Mine Name: DKG Quarry

Permit number: M/015/041

Inspection Report Minerals Regulatory Program

Report Date: November 19, 2004

Photo 4. Panorama of the area being reclaimed. There is some distortion in this picture.

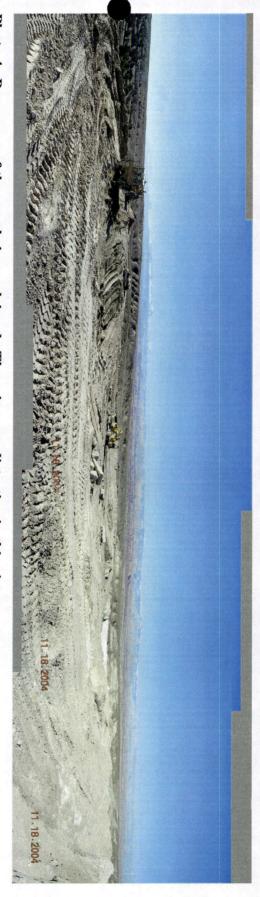
Photo 4 is a composite of four photographs and shows the main area being regraded. The grading is being done to give some variety to the terrain, and I am pleased with the work so far. The operator needs to keep in mind how water would flow and how it would get to the main drainages.

There are some large rocks on the surface (Photo 4), but anything the operator can do to also have more small rocks—sandstone, gypsum—would be beneficial.
